T.Y. LIN INTERNATIONAL
 THE STAMPED DOCUMENTS ARE HEREBY:

PROJECT NAME: BROOKFIELD
 PROJECT NUMBER: BRF FLBR(2)

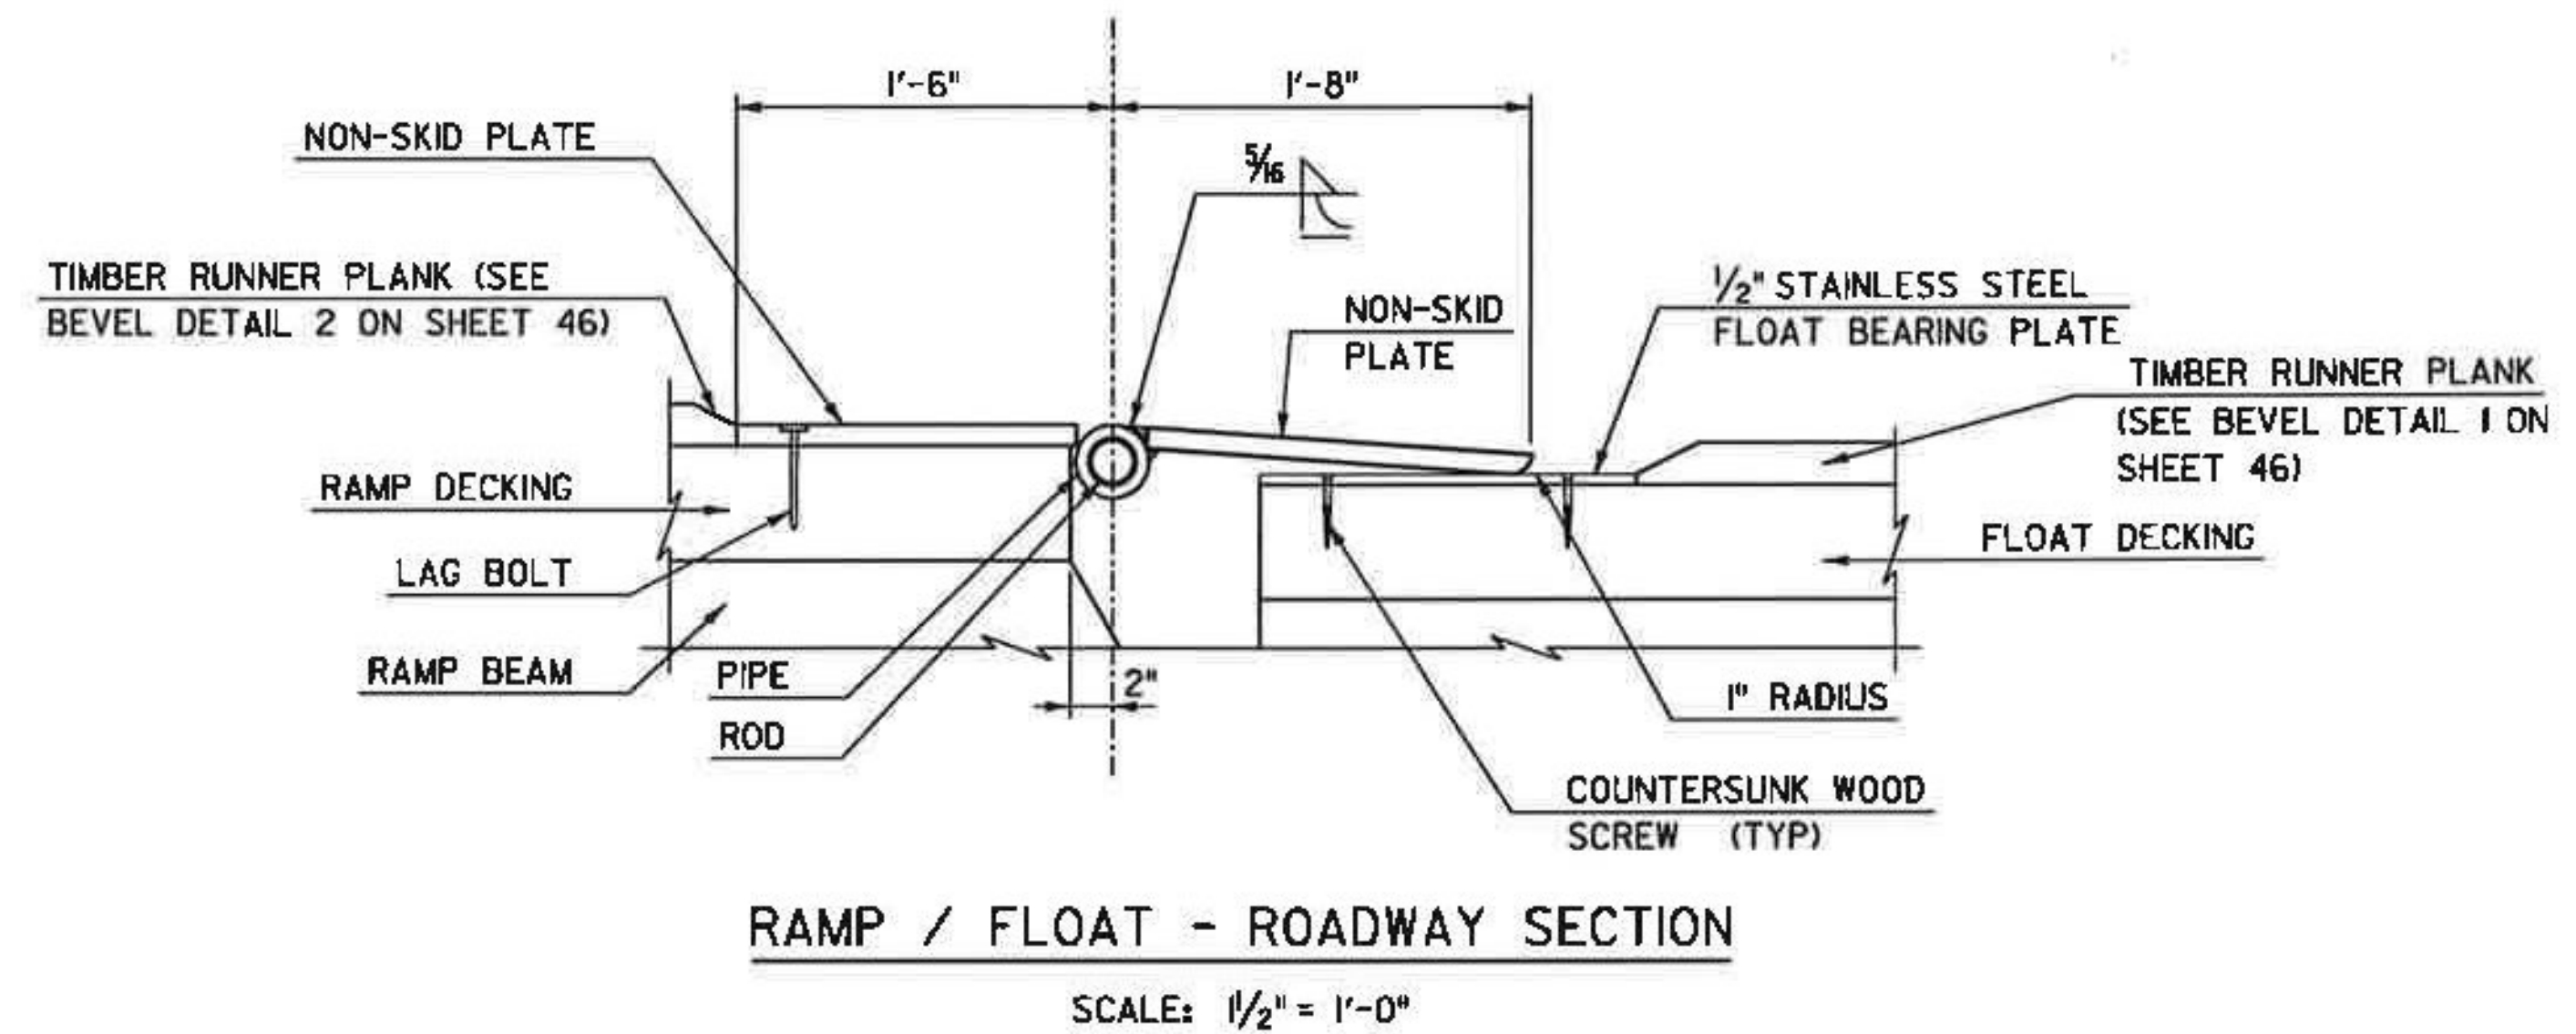
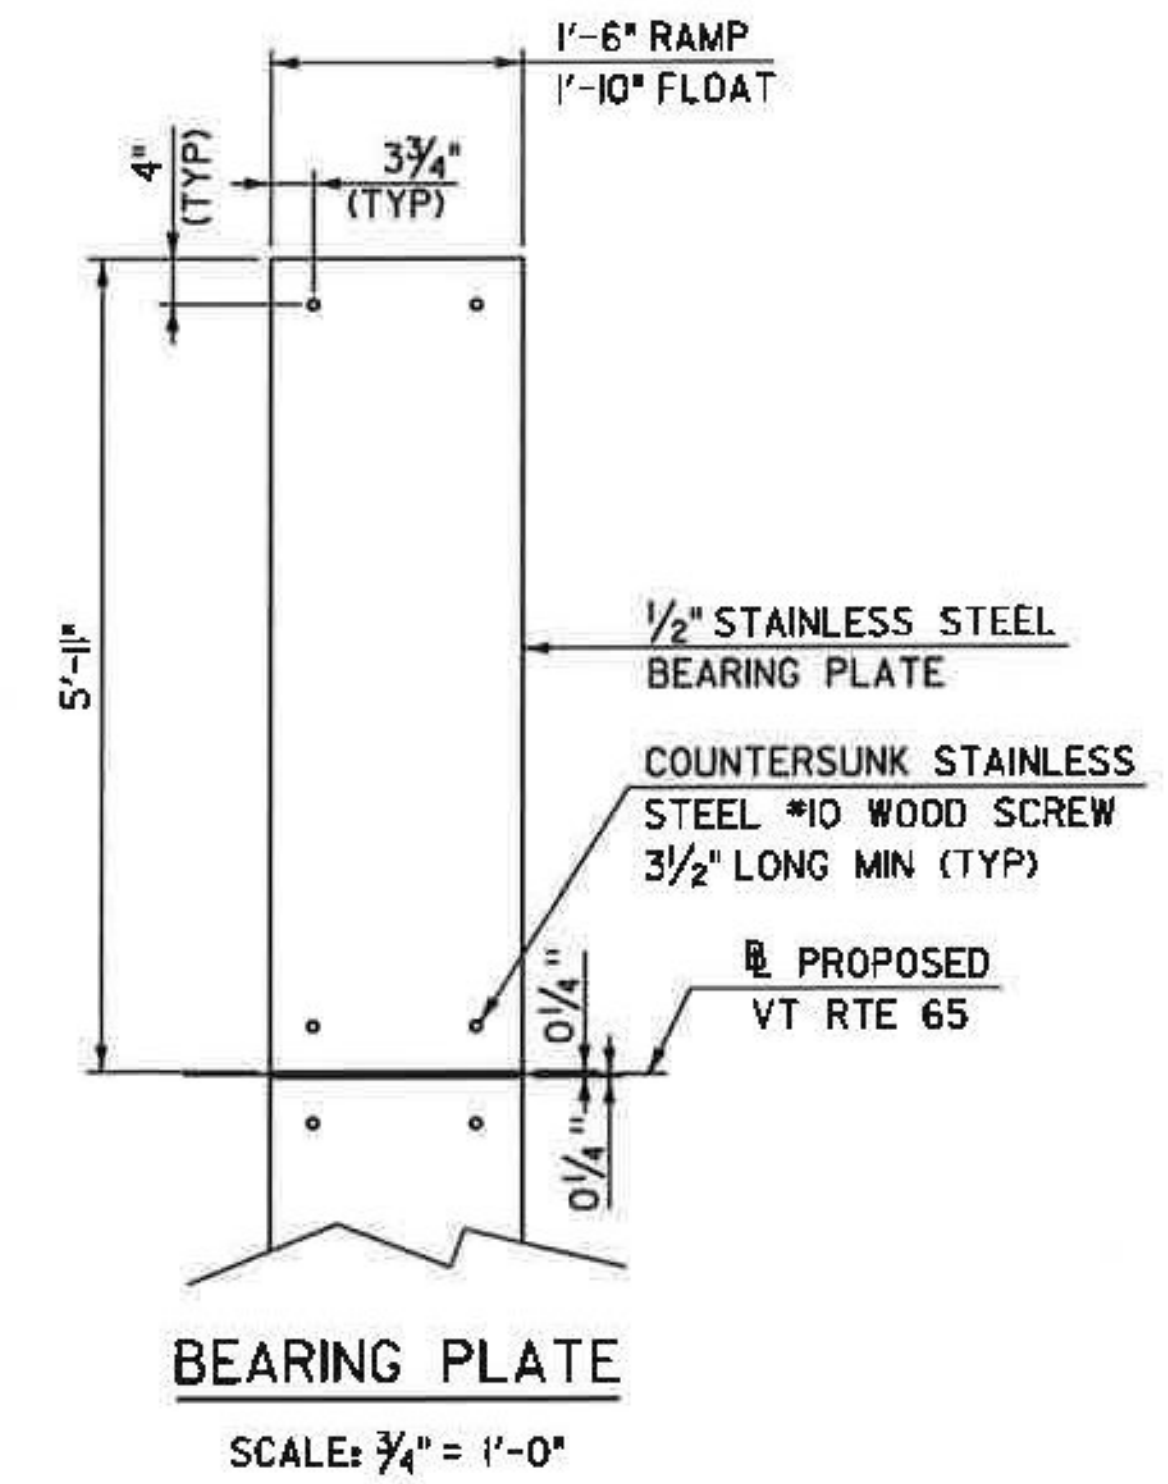
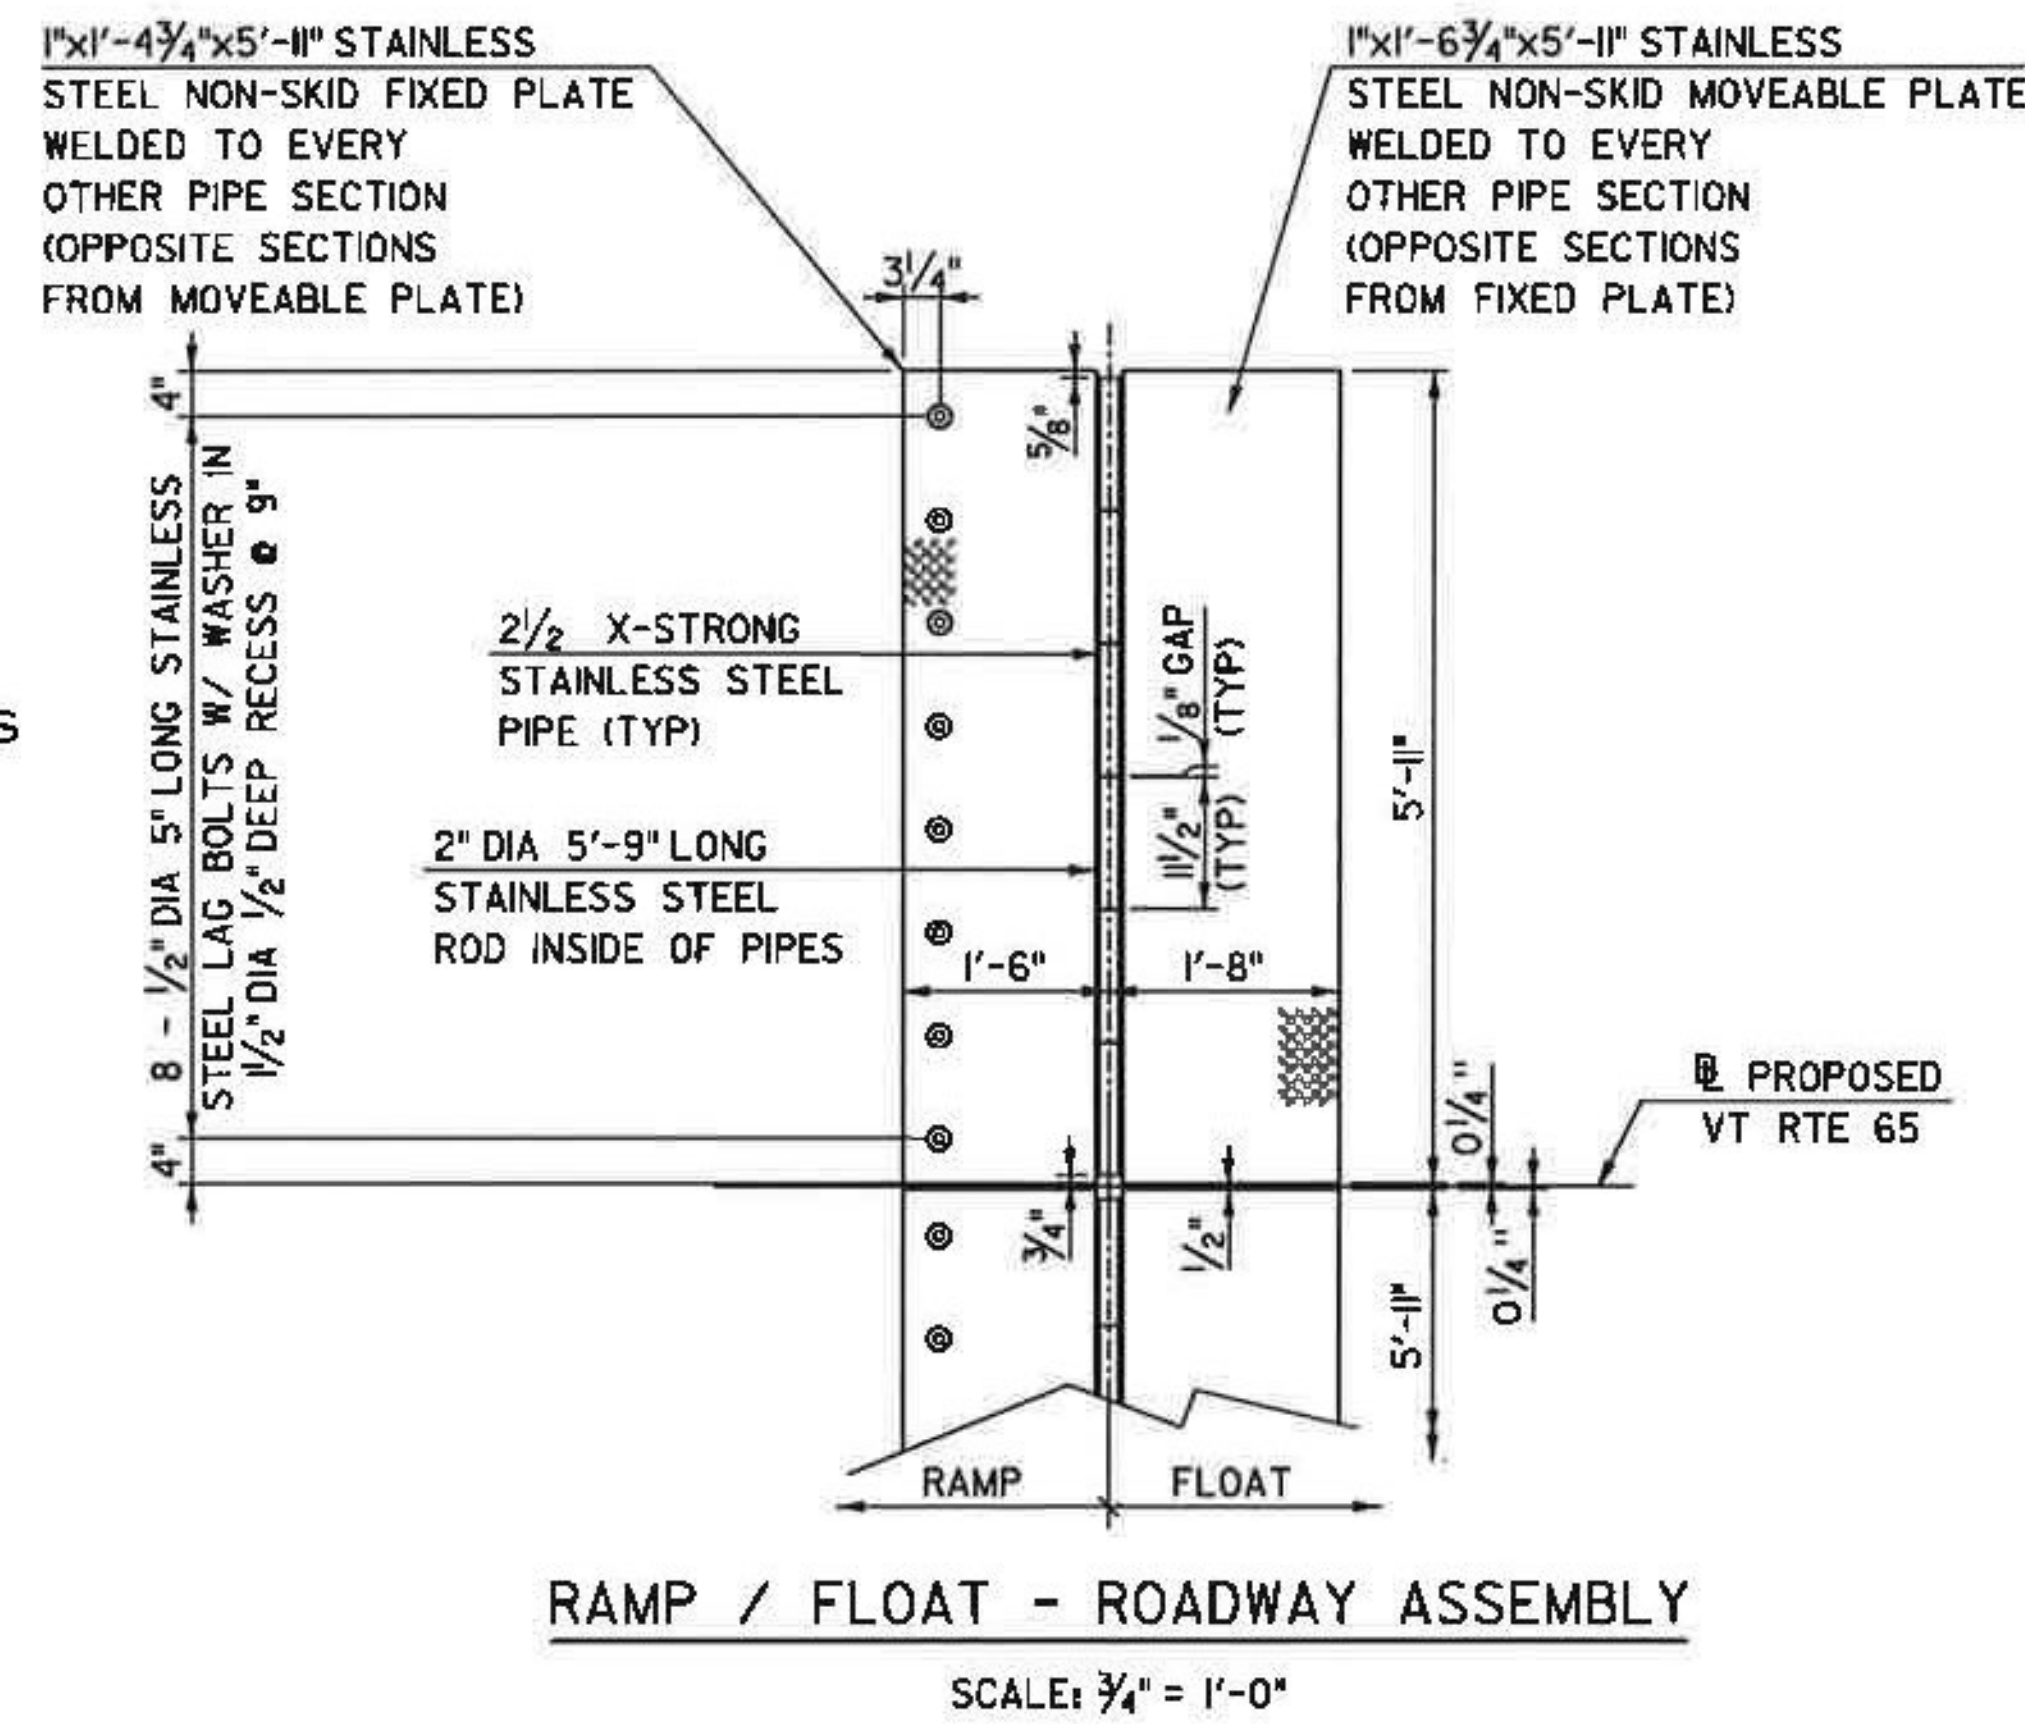
1/2" dia. lead hole for Shank portion of lag bolt, and suggest 5/16" dia lead hole for the threaded portion of the lag bolt to avoid splitting

1/4" dia. lead holes for 1/2" lag bolts
